PLANNING COMMISSION
Staff Report

Site Plan
Thursday, September 24, 2020
Public Meeting

The applicant requests review and approval of the proposed site plan to locate a KFC Restaurant s at 1378 N. Exchange Drive in the RC zone.

Date Received:	**Resubmittal –** 04/24/2020
Date of Review:	**05/07/2020**
Project Name:	KFC
Project Request / Type:	Site Plan
Meeting Type:	Administrative
Applicant:	Hugh Murphy
Owner:	Harman Management Corporation
Location:	Crossroads and Exchange Drive
Major Street Access:	1378 N EXCHANGE DR
Parcel Number(s) and size:	66:687:0301; .80 acres
Land Use Designation:	Regional Commercial
Parcel Zoning:	Regional Commercial
Adjacent Zoning:	Regional Commercial
Current Use:	Vacant
Adjacent Uses:	Vacant; Commercial
Previous Meetings:	Planning Commission and City Council
Previous Approvals:	Concept Plan (9-27-17) and Plat Approval (5-11-18)
Type of Action:	Approval/Denial
Land Use Authority:	Planning Commission
Future Routing:	
Planner:	Gina Grandpre, Planner II

EXTERIOR LIGHT FIXTURE DETAILS N.T.S. A

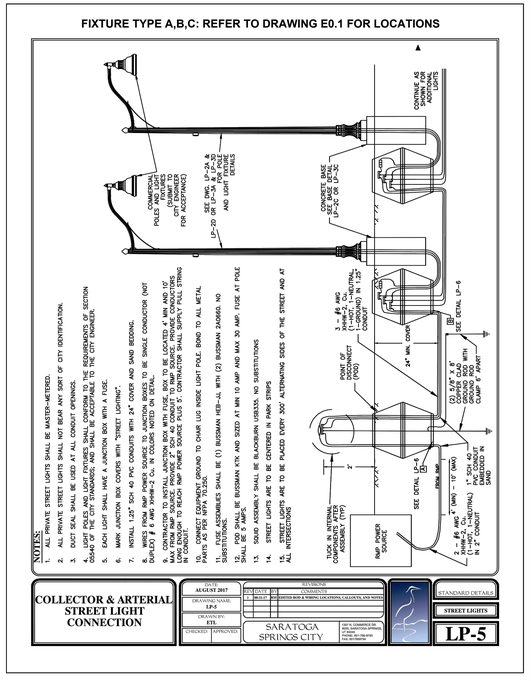
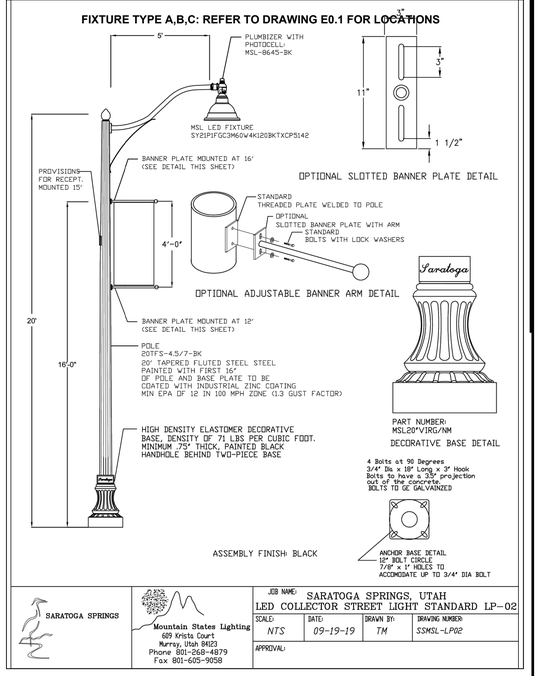
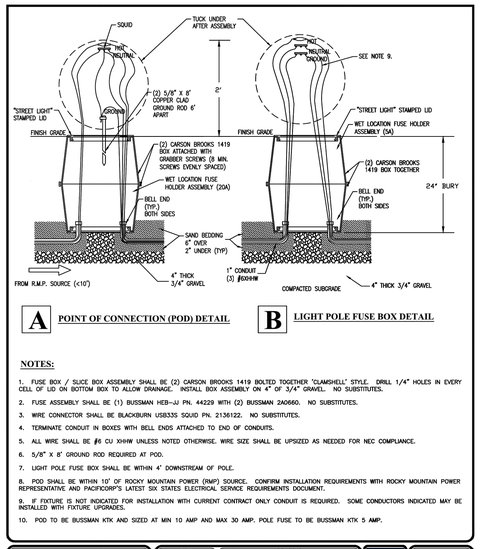
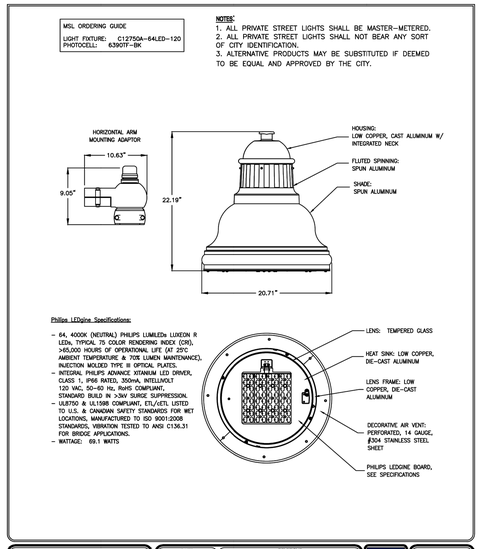
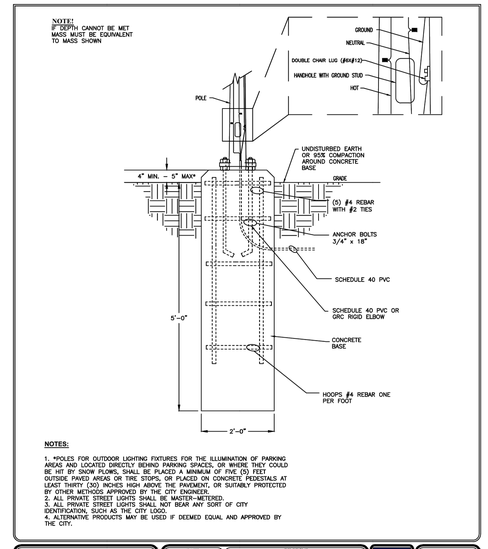
Regulation	Compliance	Findings
Material: All Lighting Fixtures and assemblies shall be metal.	**Complies.**	
Base: All lighting poles shall have a 16" decorative base.	**Can Comply.**	*Provide new light pole detail with decorative bases.* ***Complies***
Type: All lighting fixtures shall be of the full cutoff variety. Shoebox fixtures are prohibited.	**Can Comply.**	*Provide new light detail with Arm and bell shade.* ***Complies***
Angle: Shall be directed downward.	**Complies.**	
Lamp: Bulbs may not exceed 4000k.	**Complies.**	
Drawings: Design and location of fixtures shall be specified on the plans.	**Can Comply.**	*Need new detail on lighting ole fixtures, and wall mount details.* ***Complies***
Flags: The Unites States flag and the state flag shall be permitted to be illuminated from dusk till dawn. All other flags shall not be illuminated past 11:00 p.m. Flag lighting sources shall not exceed 10,000 lumens per flagpole. The light source shall have a beam spread no greater than necessary to illuminate the flag.	**N/A.**	*No flag pole shown*

All trespass lighting shall not exceed 1.0 foot-candles measured at the property line, except that trespass lighting into residential development shall not exceed 0.1 foot-candles measured at the property line.	**Complies.**	
Service station canopies must utilize canopy lights that are fully recessed into the canopy or are fully shielded by the canopy.	**N/A.**	
All freestanding lighting fixtures and assemblies shall be black. Regional Parks may include theme lighting fixtures in colors other than black. The color shall enhance the theme of the park and shall be approved during the site plan review process.	**Can Comply.**	*Need new detail on lighting ole fixtures, and wall mount details.* ***Complies***
Pole design shall include an arm and bell shade. Regional Parks may include theme lighting fixtures that do not include an arm and bell shade. The design shall enhance the theme of the park and shall be approved during the site plan review process.	**Can Comply.**	*Provide new light pole detail with Arm and bell shade.* ***Complies***
